Re: Report of Abnormal Occurrence
Oyster Creek Nuclear Generating
Station, Unit No. 1
October 2, 1969

The inability to meet a limiting condition for operation at the Oyster Creek Nuclear Generating Station of the Jersey Central Power and Light Company on October 2, 1969. Reference AEC Operating License DPR-16, Technical Specifications, thereof, Section 3.2 "Reactivity Control," Specification B, Sub-Specification No. 3 - "The average of the scram insertion times of all operable control rods shall be no greater than:"

EXHIBIT A
Schematic Diagram -- Model TR-DB-144-A1 Control Rod Drive Mechanism

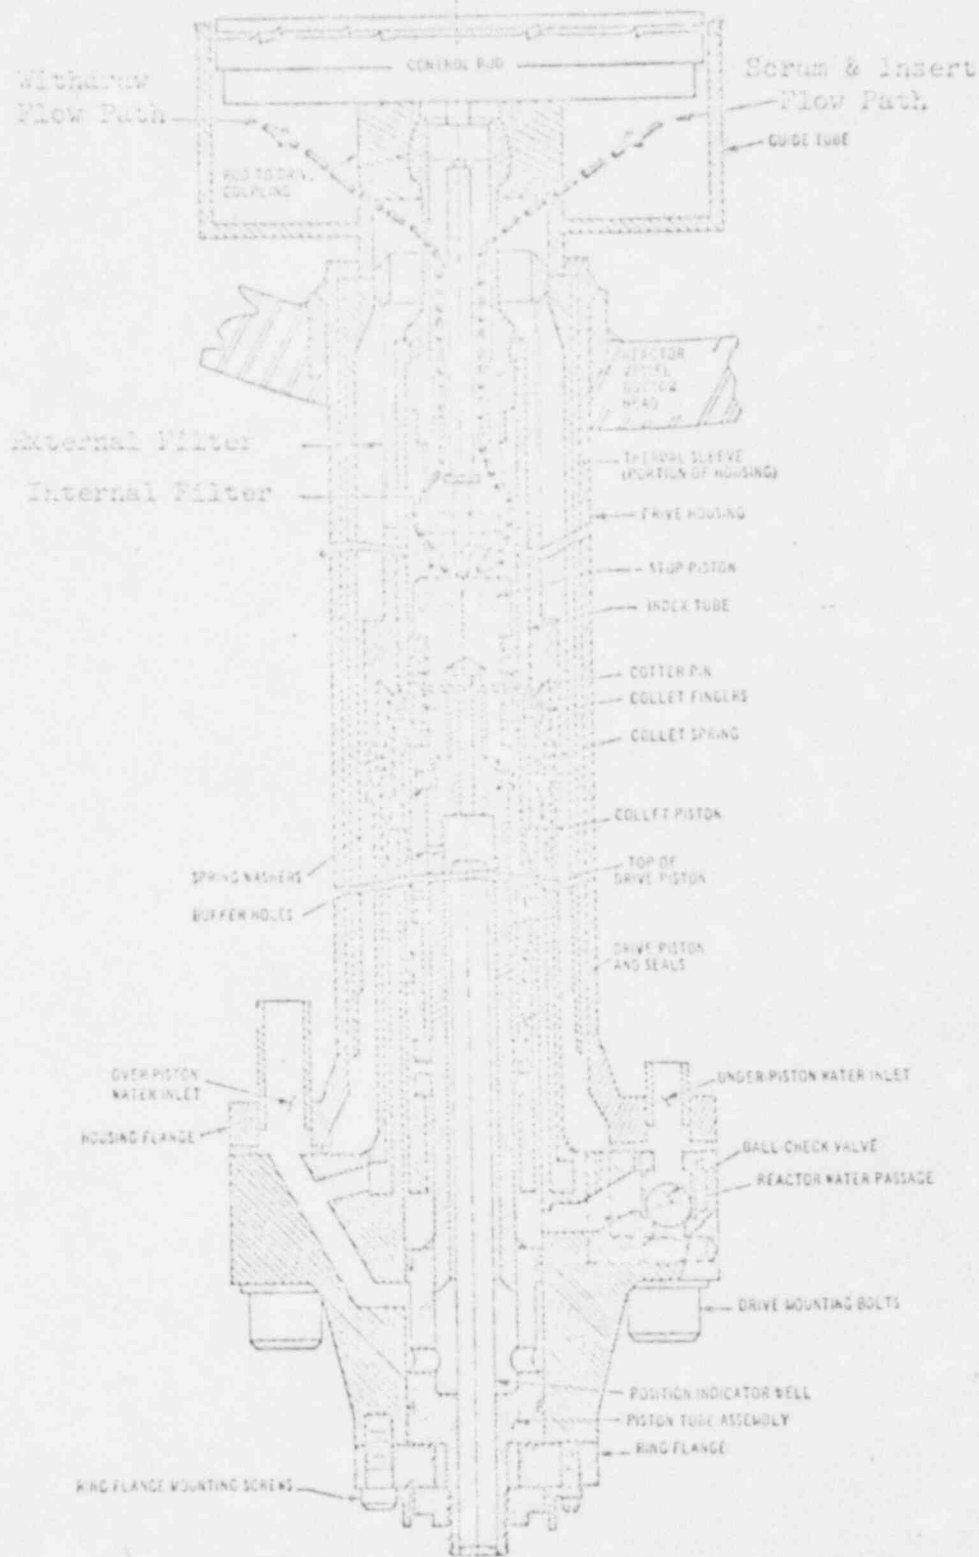
No! - only because the
seals leak do the drives
scram with a completely
sealed internal filter.

How about plugged External filter?
